Final Report
on
Vertical Fire Dampers
for the
SNLPPS Project

Bechtel Power Corporation
Gaithersburg, Maryland
February 12, 1980

CHANGE LETTER	REVISION DESCRIPTION	OWN. BY	APP'VD. BY	DATE
	RUSKIN Mfg. Co.			
	P.O. Box 129			
	Grandview, Mo. 64030			
	TITLE			
	VERT. NIBD 23 SPRING			
	: BRACKET MODIFICATION			
	DWG. NO.			
				5398

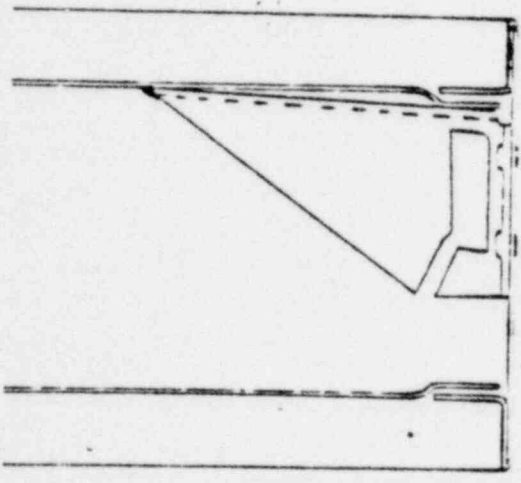
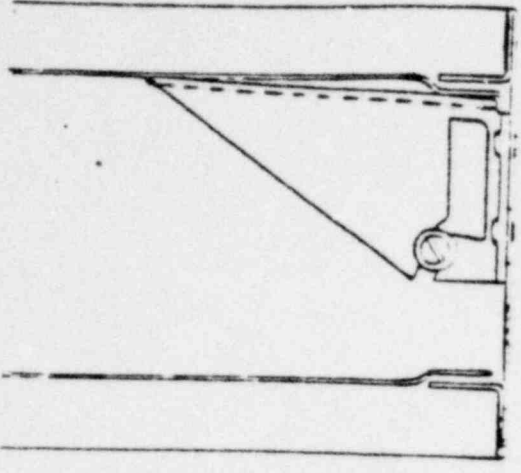
A bracket at the lower end of the vertical dampers holds the spring which is connected to the damper blade. The brackets were originally designed to be installed as shown in the left hand sketch of Ruskin Manufacturing Company Drawing No. 5398 (copy attached). To provide extra support for the bracket, Ruskin decided to tack weld the top edge of the bracket to the damper blade guide, as shown in the middle sketch on Ruskin Drawing No. 5398. The tack welding resulted in widening of the gap in the brackets and allowing the springs, in some instances, to slip out while they were recoiling during closure of the damper.

ORIGINAL INSTALLATION
(VERTICAL FIRE DAMPERS
WITH SPRING CLOSURE)

TOP EDGE OF BRACKET
TACKWELDED TO PROVIDE
EXTRA SUPPORT FOR
BRACKET & RESULTING
ALTERATION OF SPRING
SLOT

A #6 screw using a washer, star lockwasher, and hex nut, will be installed in the narrow portion of the spring slot, as shown in the Ruskin Manufacturing Company Drawing No. 5398. The vertical fire dampers for Callaway Jobsite have been returned to Ruskin for necessary modification. Fire dampers for Wolf Creek, not yet installed, will either be returned to Ruskin for the necessary modification or else modified on site. Dampers already installed at Wolf Creek will be modified at the jobsite. Vertical fire dampers, not yet shipped to SNUPPS Units, will be modified prior to delivery. All vertical fire dampers modified per this report will be operationally cycled, prior to or during installation, to confirm acceptability.

PROPOSED FIX - #6 SCREW,
WASHER, STAR LOCKWASHER
& HEX NUT TO KEEP
SPRING FROM SLIPPING
OUT OF SLOT
